July 30, 2018

Louisiana Department of Environmental Quality
Public Participation Group
PO Box 4313
Baton Rouge, LA 70821

**SUBJECT: AI Number 198467,
Activity Number PER20170003
Public Comments and Hearing Request**

Thermaldyne Process Case 1 - 130°F Condenser

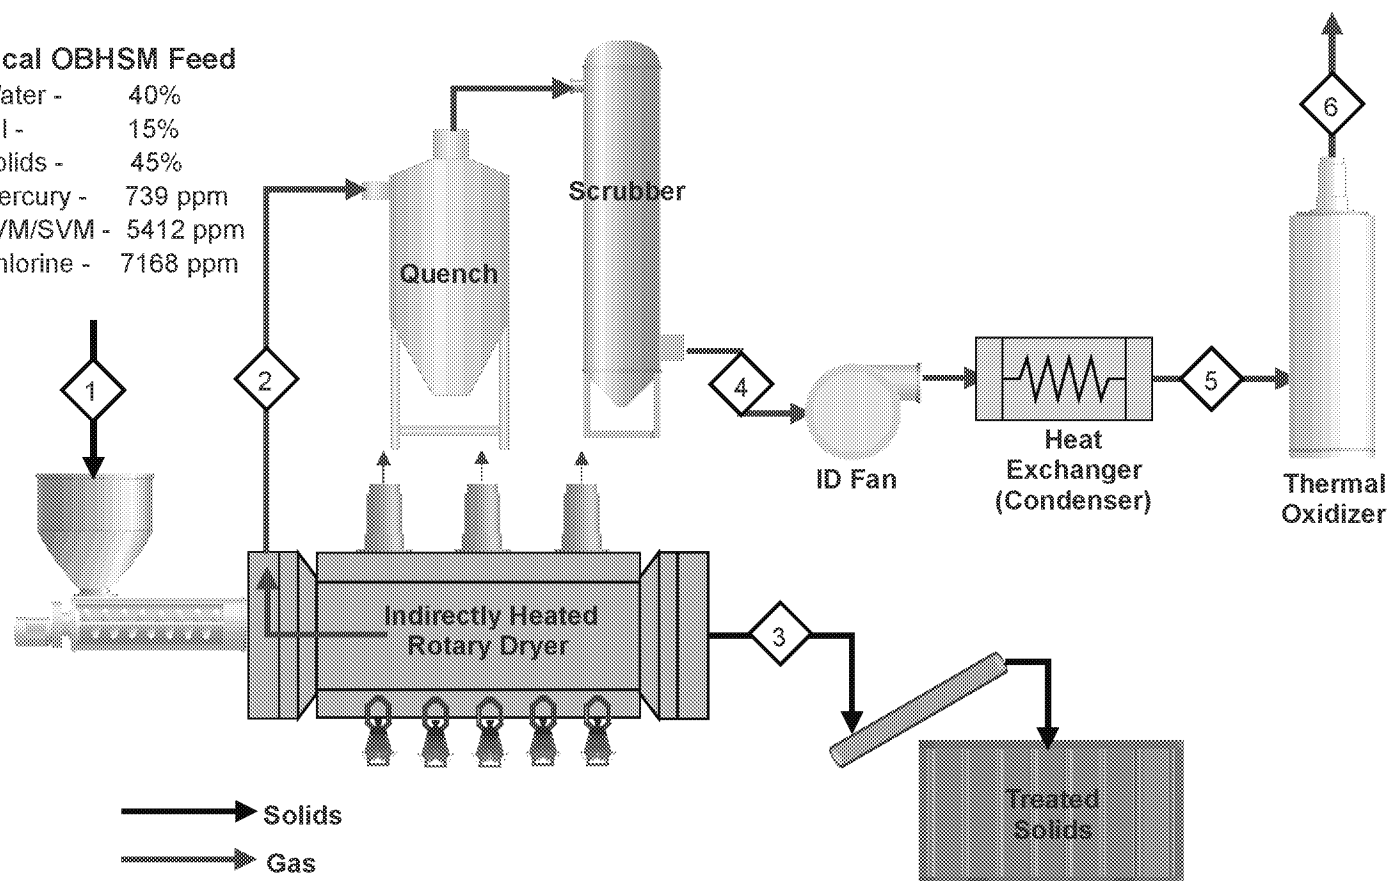
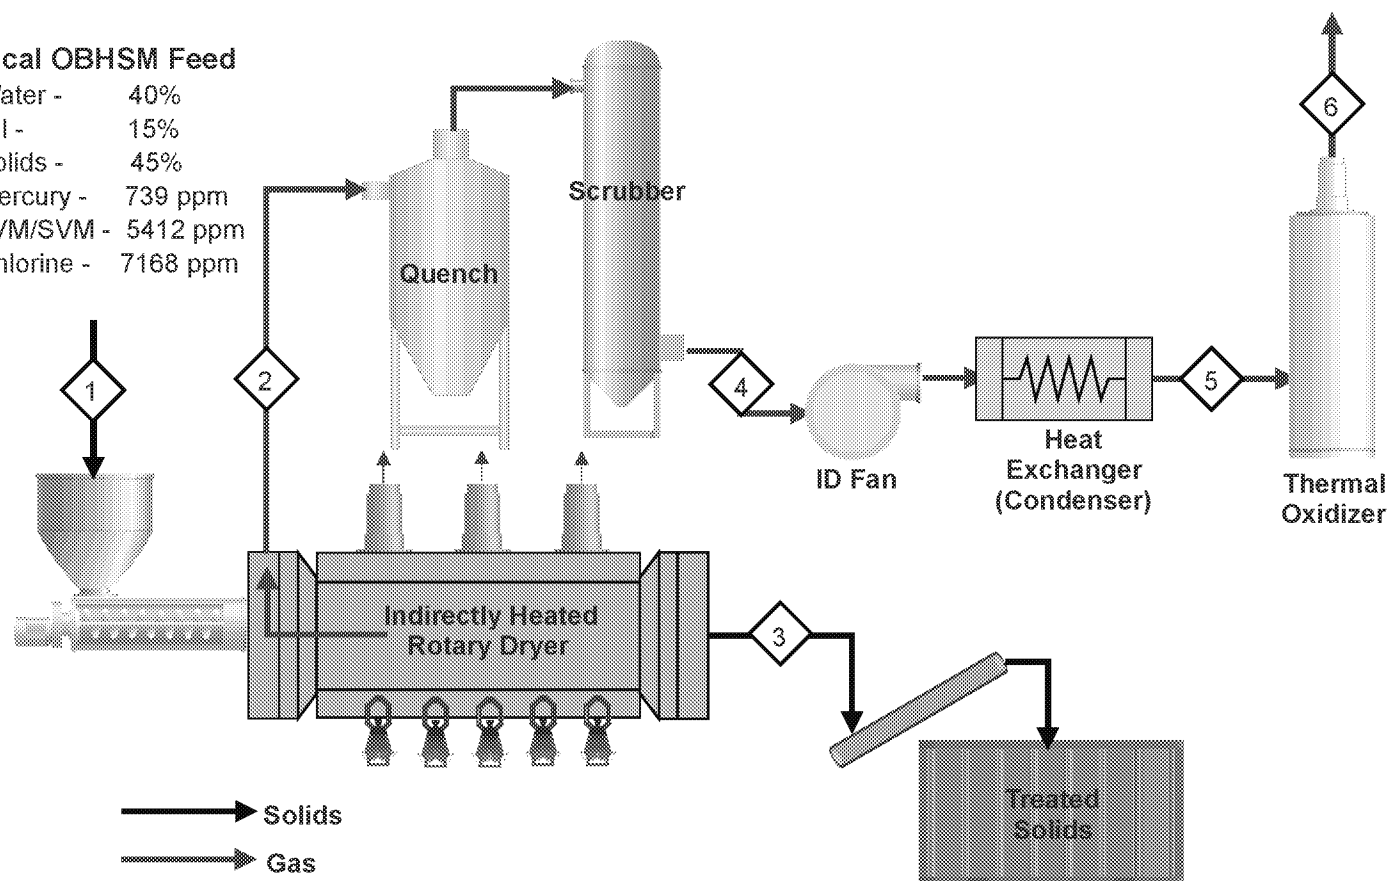
average concentrations in the feedstream at the levels shown in the Attachment 4 PFD. All exceed appropriate emission limits for hazardous waste combustors. Thermaldyne apparently acknowledges the presence of these hazardous air pollutants even though they have not represented them in the facility air permit materials. This is evidenced by these constituents being present in their VRF Application within the “Material Acceptance Plan” under section IV on the Generator Material Profile form. MACT EEE manages these toxic constituents that Thermaldyne has acknowledged are present and that they intend to process in their TDU, combust in their TDU process and release to the atmosphere without restriction.

- Mercury emissions are likely to exceed appropriate emission limits by a factor of 7,300 or more ($59,345/8.1=7,326$).
- SVM and LVM emissions are likely to exceed appropriate emission limits by a factor of 98 or more ($2,265/23=98$)
- Hydrochloric acid emissions are likely to exceed appropriate emission limits by a factor of 84 or more ($1,794/21=84$)
- None of these pollutants are restricted by either the LDEQ air permit, the draft VRF Variance, or Thermaldyne’s operating plans
